DOCUMENT 00 90 00
ADDENDUM

ADDENDUM NO. [3] Date: February 26, 2018
RE: HO-CHUNK NATION
INDEPENDENT LIVING FACILITY
BRANCHED ANTLER AVE
BLACK RIVER FALLS, WISCONSIN 54615
HSR PROJECT NO. 15027

M100R

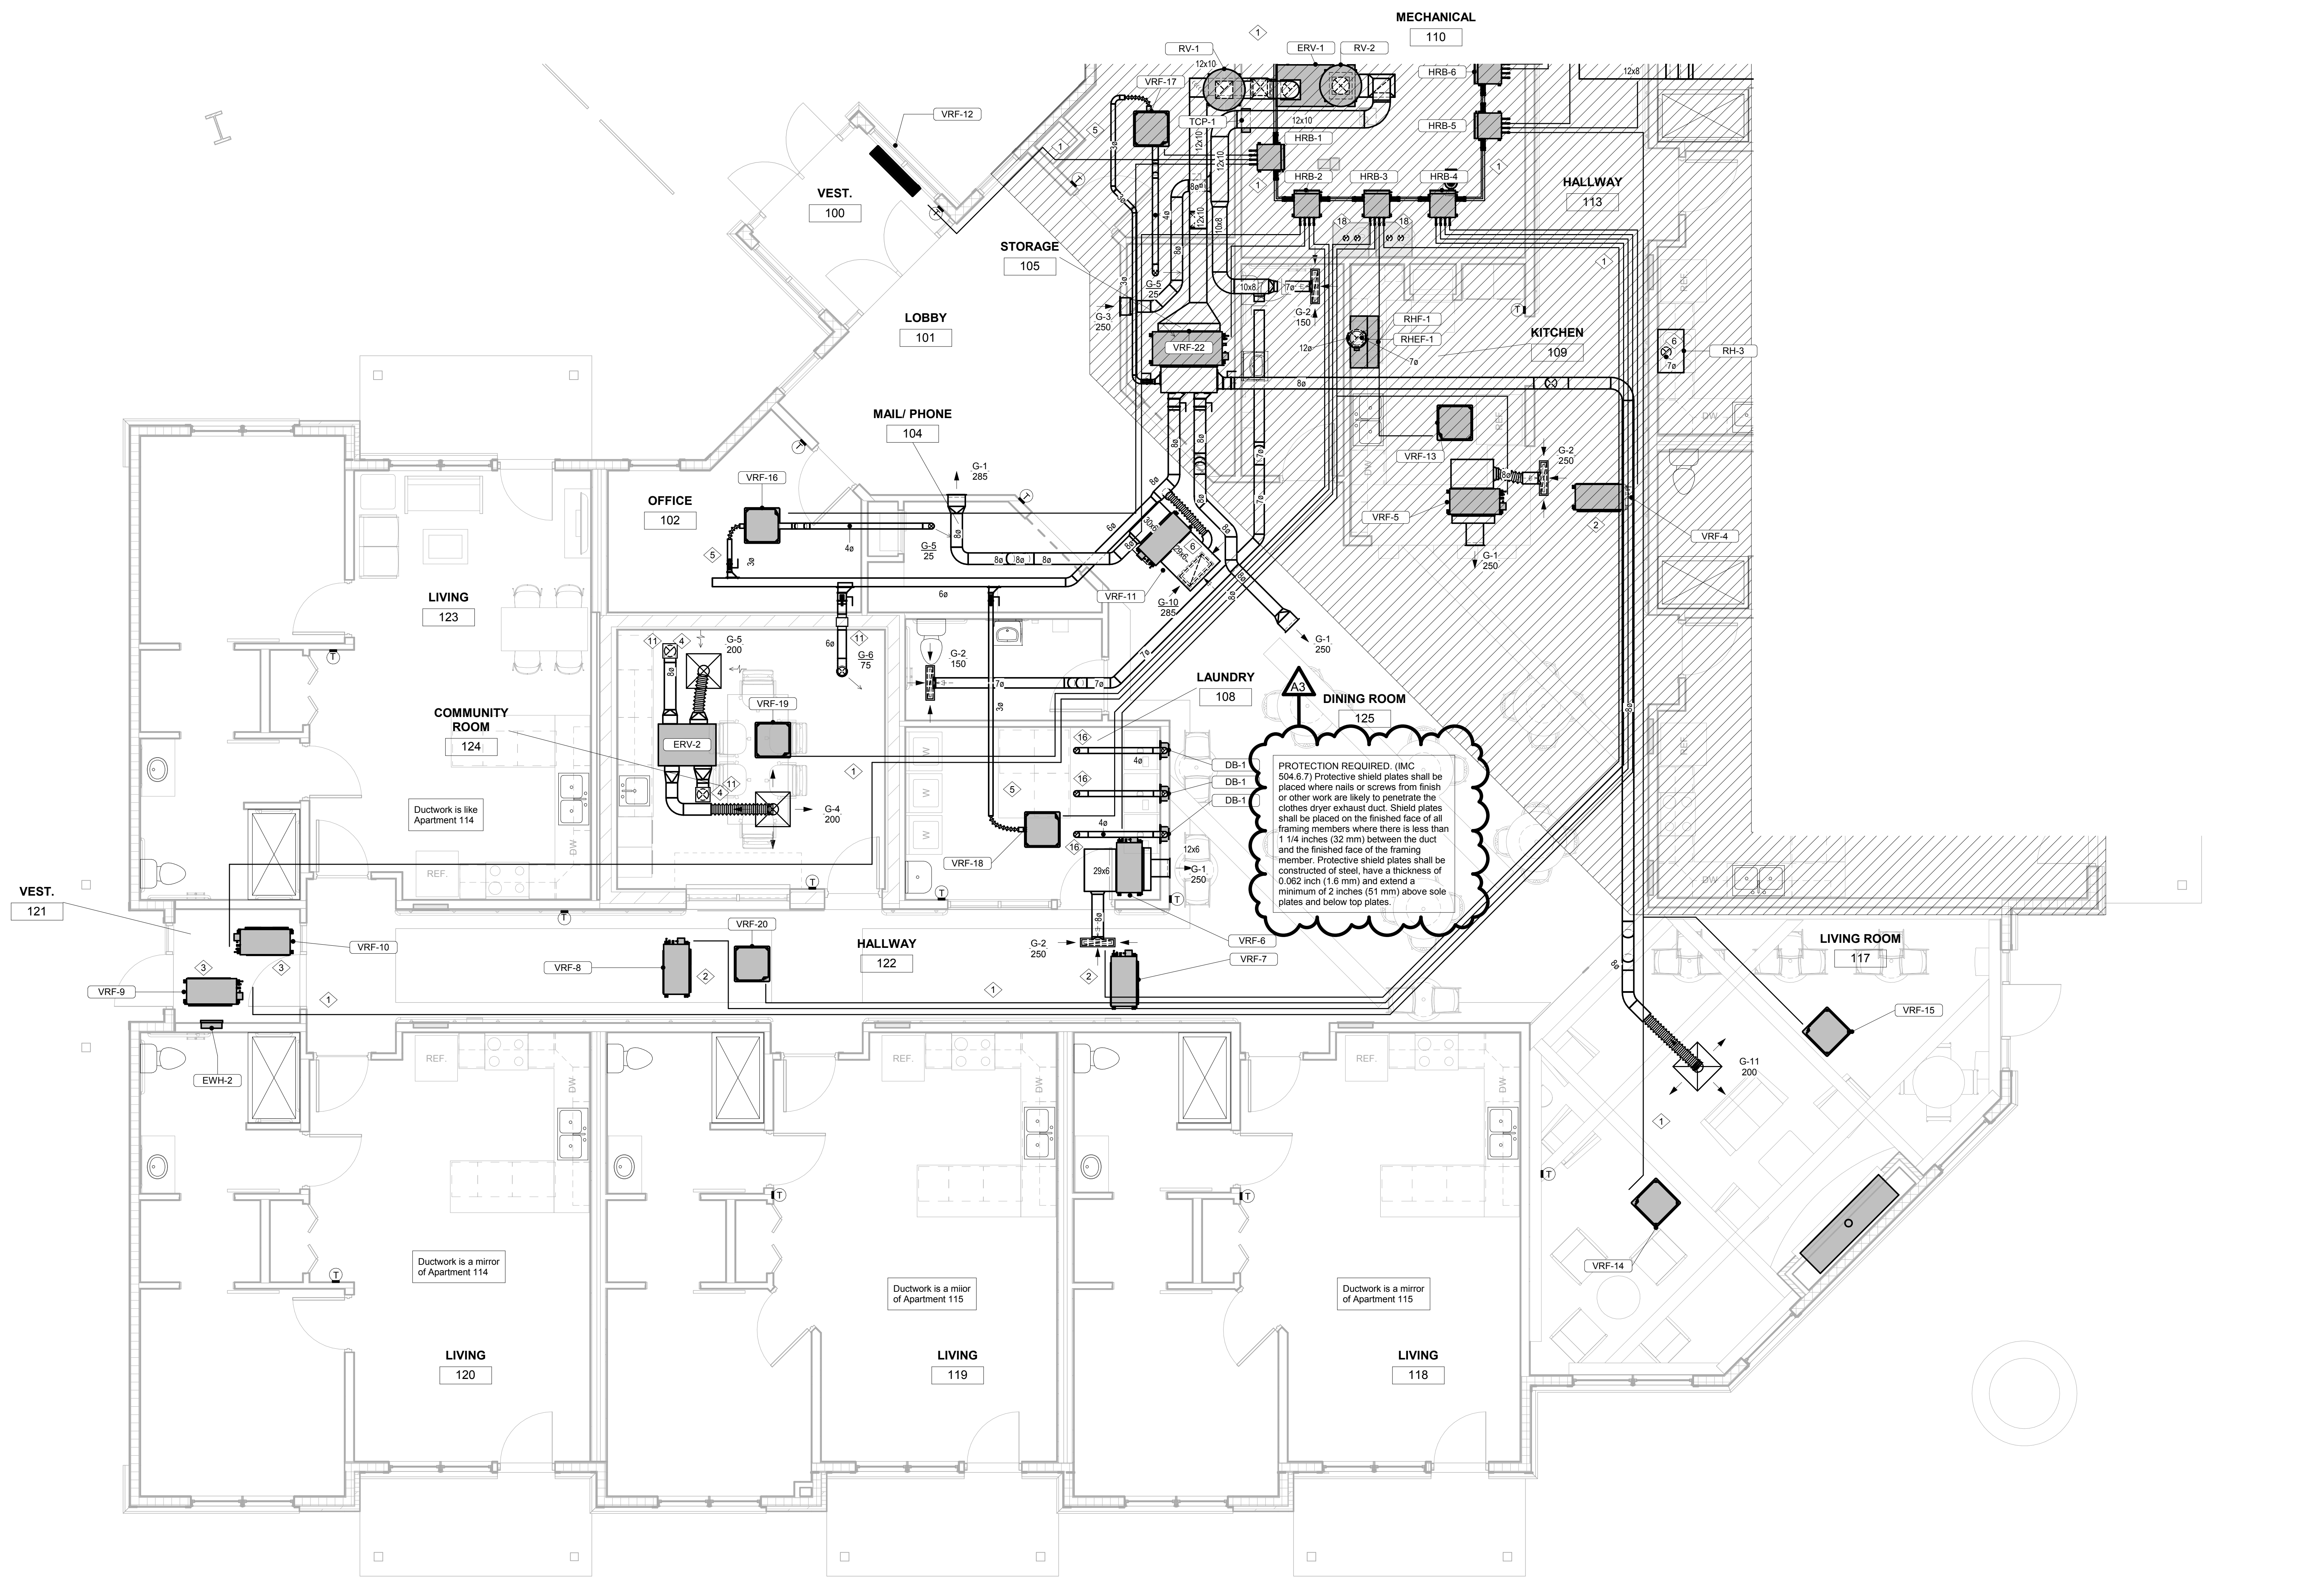
3. Sheet M100R MECHANICAL VENTILATION PLAN – SEGMENT 'A' 30 x 42 attached hereto
 - a. Revisions clouded on Drawing.
4. Sheet M101R MECHANICAL VENTILATION PLAN – SEGMENT 'B' 30 x 42 attached hereto
 - a. Revisions clouded on Drawing.
5. Sheet M104R MECHANICAL PIPING PLAN – SEGMENT 'B' 30 x 42 attached hereto
 - a. Revisions clouded on Drawing
